#### Memorandum

Date:	August 19, 2015
From:	Marie Ennis, Gabriel Pardo
To:	John Shedd
Company:	Chautauqua Institution
c:	
Project:	Chautauqua Institution Amphitheater Study: Narrative and Questions
Project #:	J3262.02

Chautauqua Institution Amphitheater. **Demo-Construction Sequence**

> Drawing No. S-SEQ-001.00

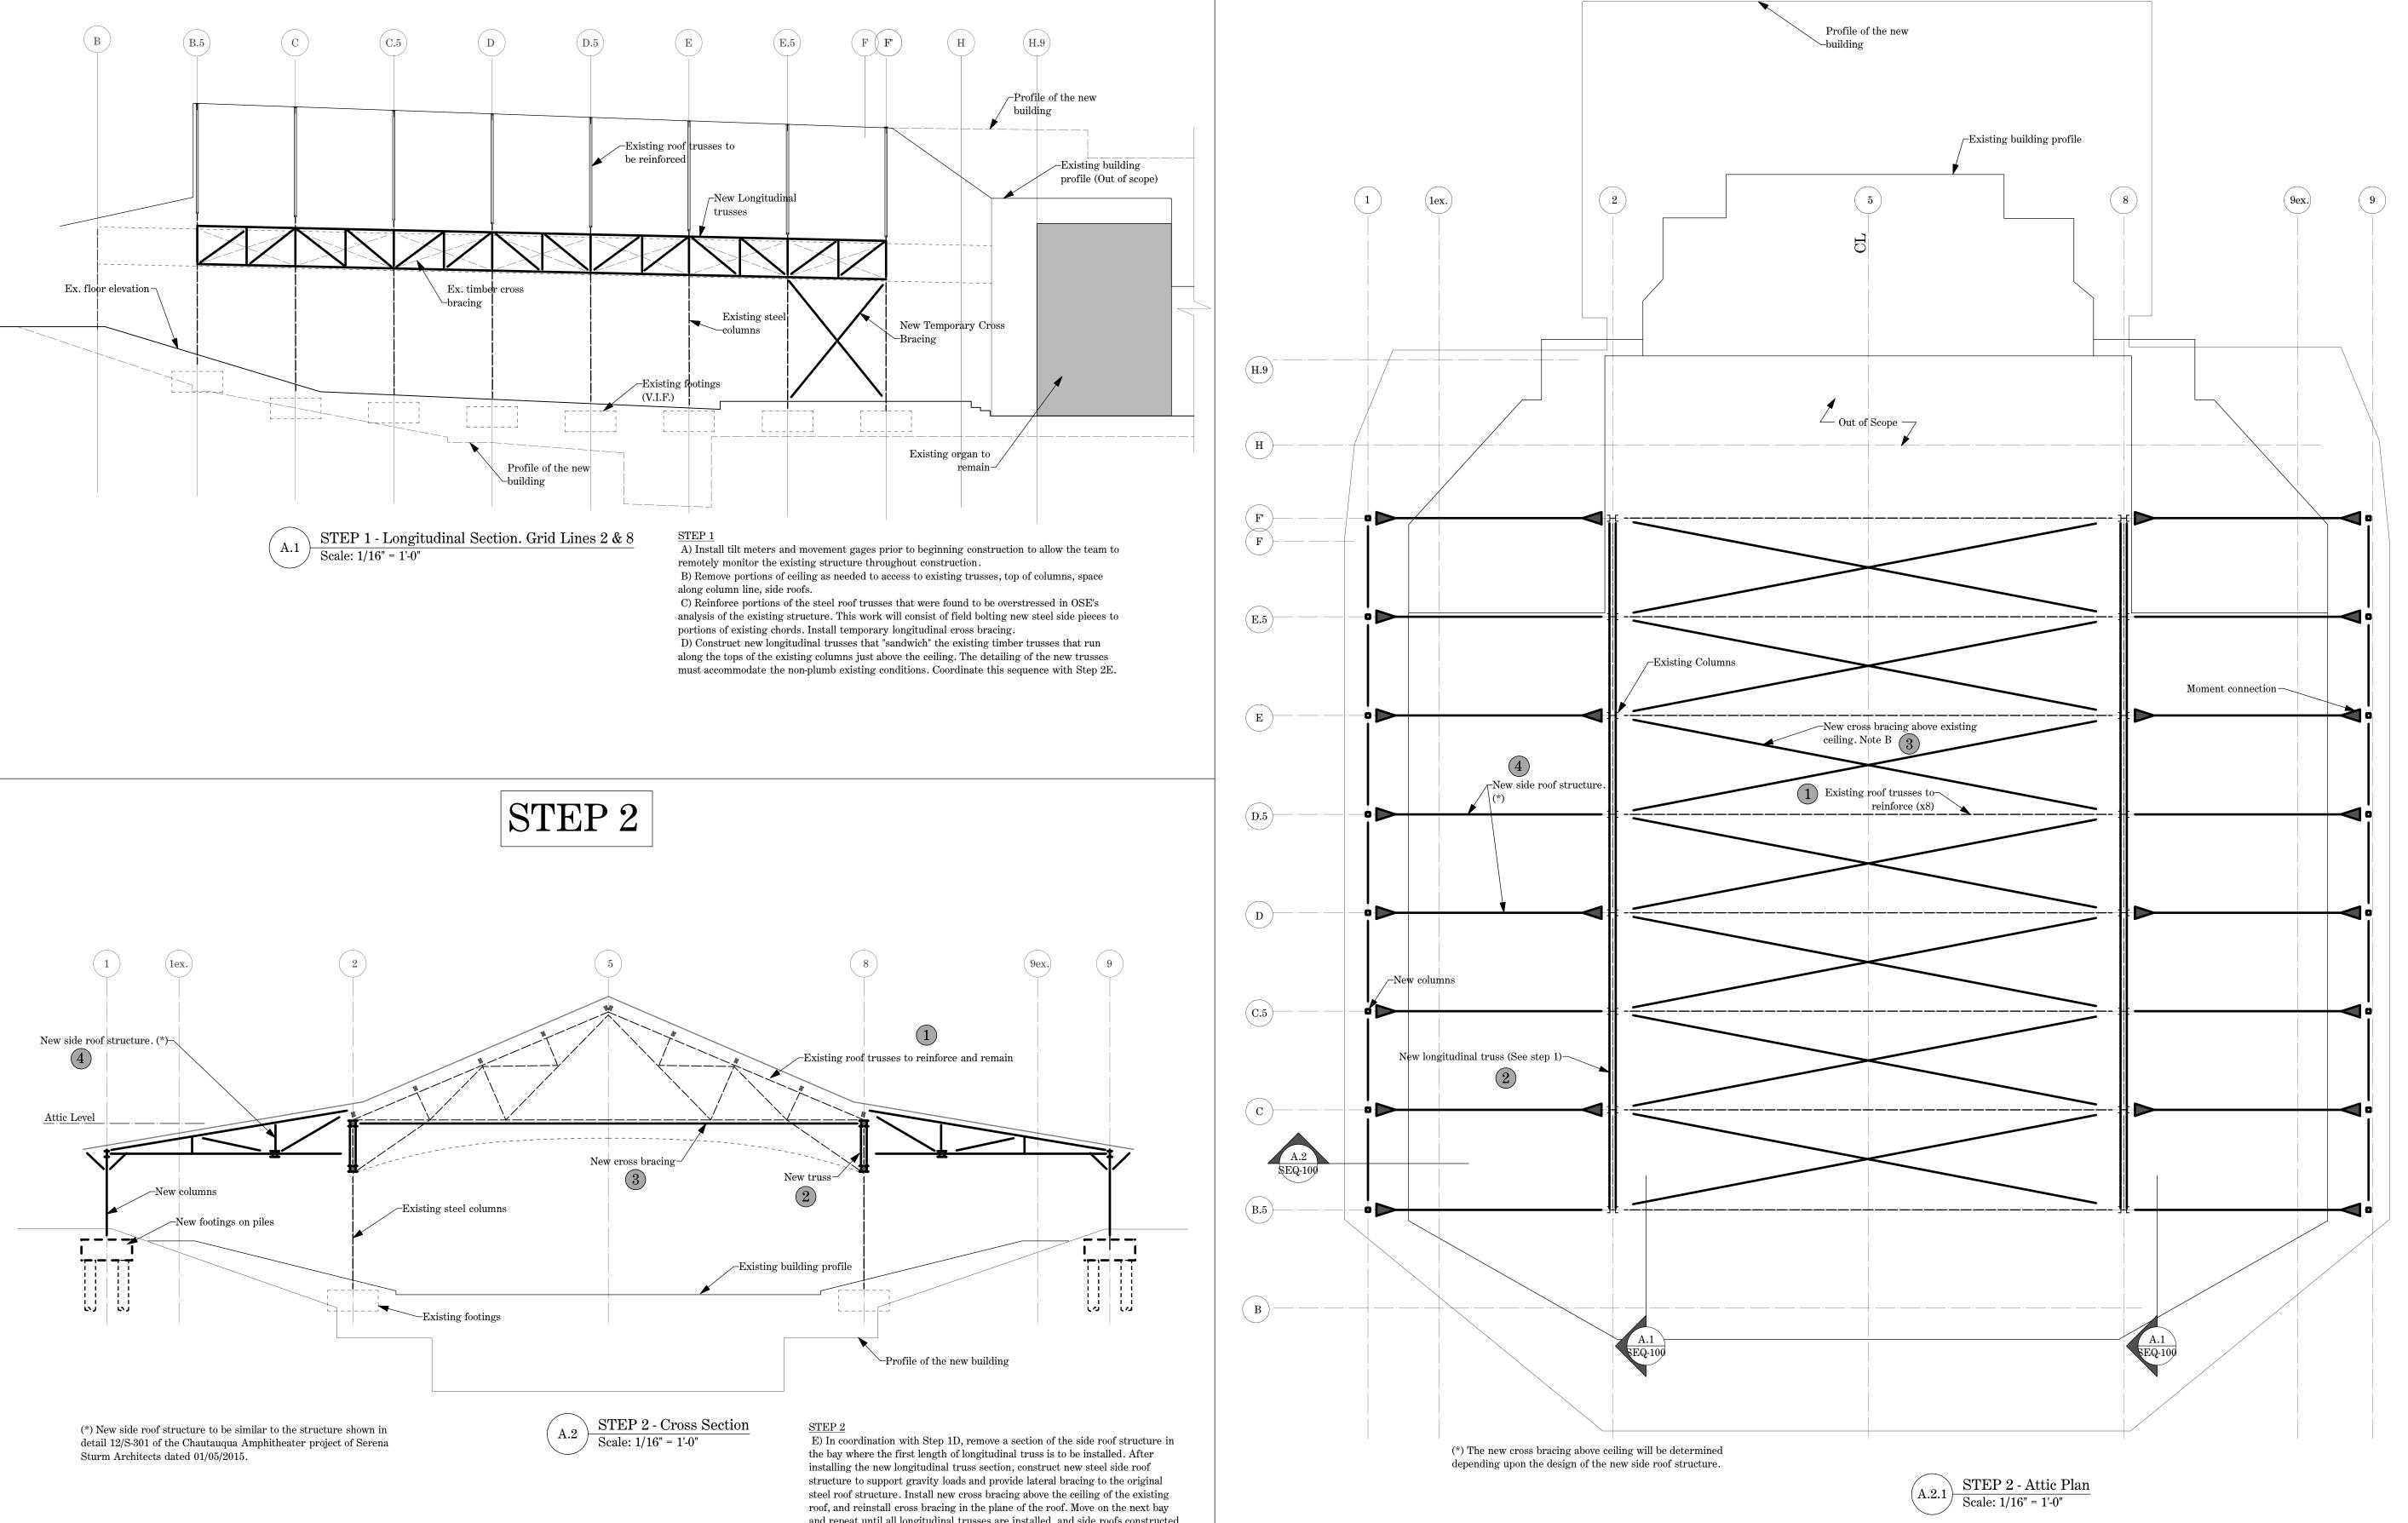
Note D "The two options presented will accommodate some added weight..." It is not clear if these criteria meet the new program needs of an additional 20 tons per truss.

The general notes on S-SEQ-001 state that not all of the design goals for the full demolition/new building could be accommodated and keep the main roof in place, therefore other non-structural aspects of the design would need to be revised accordingly. Step 4:We agree that Option B has some advantages over Option A.Step 5:Resolved by using micro-piles or mini-caissons.Steps 6 & 7:See Option A Step 6.

> Drawing No. S-SEQ-100.00

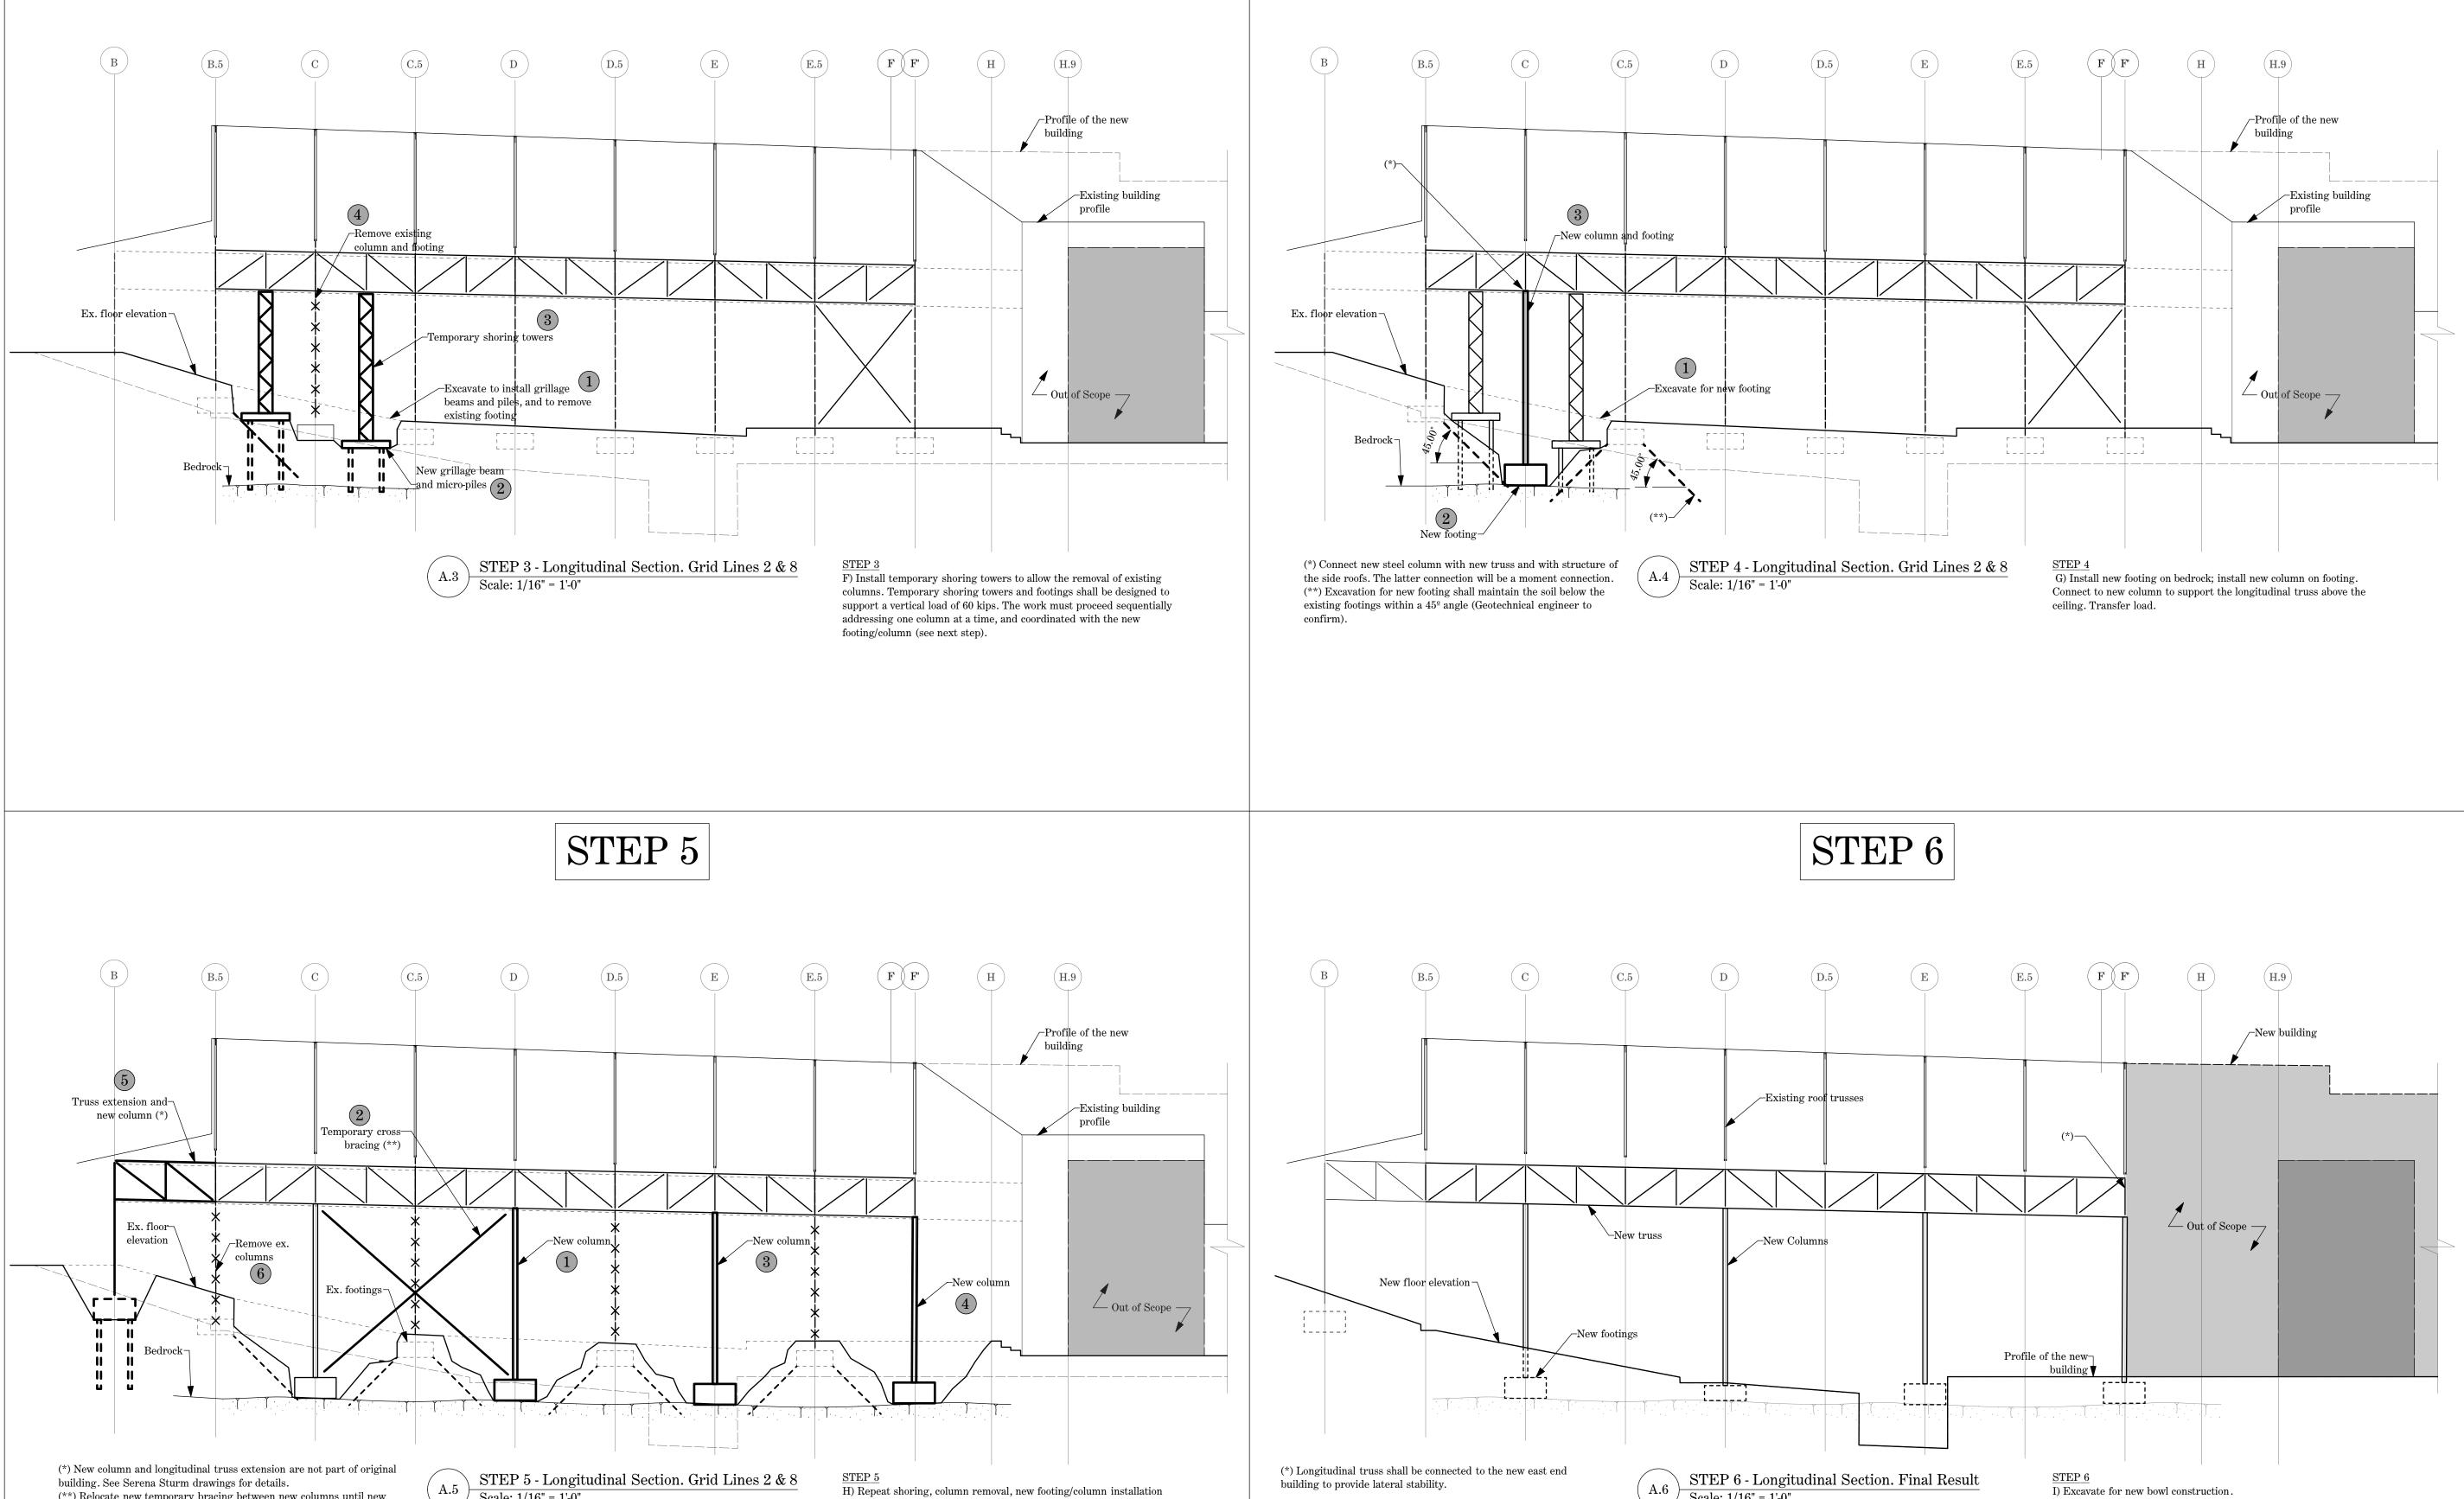
The existing trusses/columns are not uniformly spaced, therefore fabrication and fitment of the new longitudinal trusses will be difficult, and field re-work is likely needed.

The report does not address the removal or shoring/temporary support of the existing "side roof" trusses. To facilitate the installation of the new outboard longitudinal truss, the existing "side roof" trusses must be removed in their entirety or temporarily supported and have enough material removed to facilitate the installation of the new longitudinal truss.

The installation of the new cross bracing above the ceiling will likely be difficult to install physically in place, and will likely require that much of the existing ceiling material be removed.

Steel fabrication: Our experience with older steel buildings - their repair and reinforcement - is that each project is unique. The steel work must be clearly detailed, and the steel fabricator must submit shop and erection drawings with sufficient information to demonstrate their understanding of the required work. Ideally field re-work is kept to a minimum; proposed field modification methods need to be submitted for review prior to construction. Staging and rigging will also be critical aspects of the work. Side roofs: We have revised our schematic drawings and narrative to better describe the phasing and coordination between the longitudinal truss installation and the removal and reconstruction of the side roofs.

Yes, at least portions of the ceiling must be removed to gain access to existing and to install new structure. As to the cross bracing, this work is similar to some of the retrofit previously installed in the amphitheater attic (e.g., Albert Kreutter circa 1978), so it is feasible.
